To: David Greaves, Enspire
From: Steve White, Enspire
CC: Ella Tennent, Bay of Plenty Regional Council
Date: 14 March 2025
Re: Stella Passage Fast Track Application - Marine Ecology Technical Review

Re: Review of SLR AEE on marine mammals and draft Conditions

**Re: Review of SLR “Review of Marine Mammal Assessment and Consent Conditions
Port of Tauranga, Stella Passage Development, FTA Application”**

RE: REVIEW OF THE PORT OF TAURANGA EXPANSION PROJECT LANDSCAPE ASSESSMENT.

Figure 1. NOx annual record from Whareroa Marae Monitor in 2024.

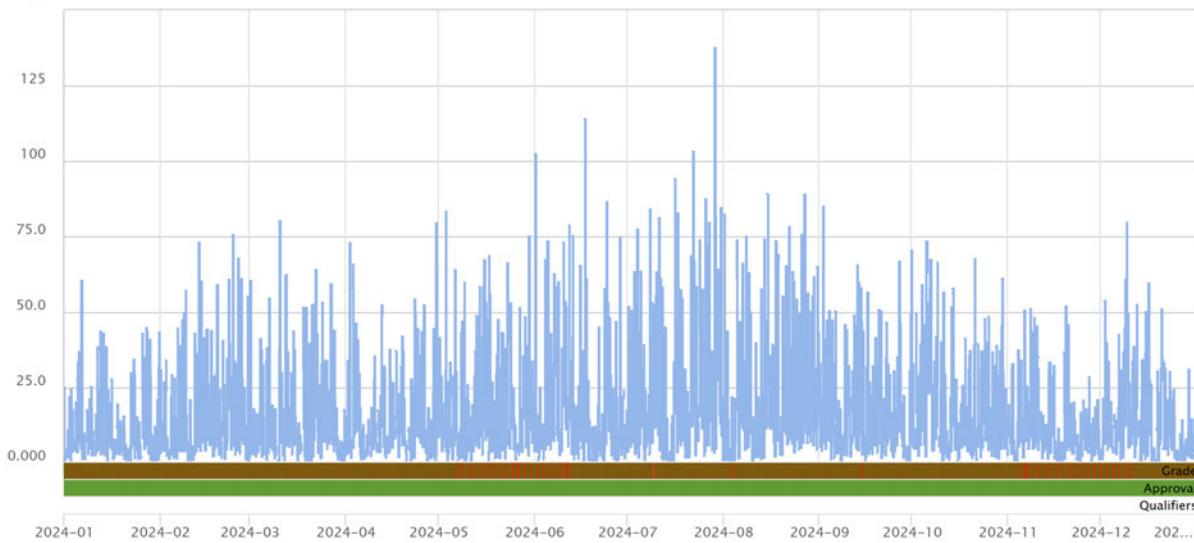
First, the relationship between ‘no-ships’ at Berth 11 and ‘ships’ at Berth 11, is just a difference of 5 $\mu\text{g}/\text{m}^3$ at the Whareroa Marae monitor. This is barely 15% of the average total impact of NOx measured at the monitor of 32.8 $\mu\text{g}/\text{m}^3$ (T&T Figure 11-1), and most likely simply reflects the hourly standard deviation, (natural variation in the data). Analysis of the 1-hour NOx record from the Whareroa Monitor for 2024, (Figure 1, below) shows significant hourly variation ranging from 0 $\mu\text{g}/\text{m}^3$ to well over 75 $\mu\text{g}/\text{m}^3$.

Secondly, there is no measured NOx in 2014-2023, so the assumption that each model year is either some percentage higher or lower than measured concentration (T&T Figure 11-2) is an estimate only, not based on real data. Therefore, ASG disagrees with the T&T 2024 model evaluation performance as detailed in Section 7.5.
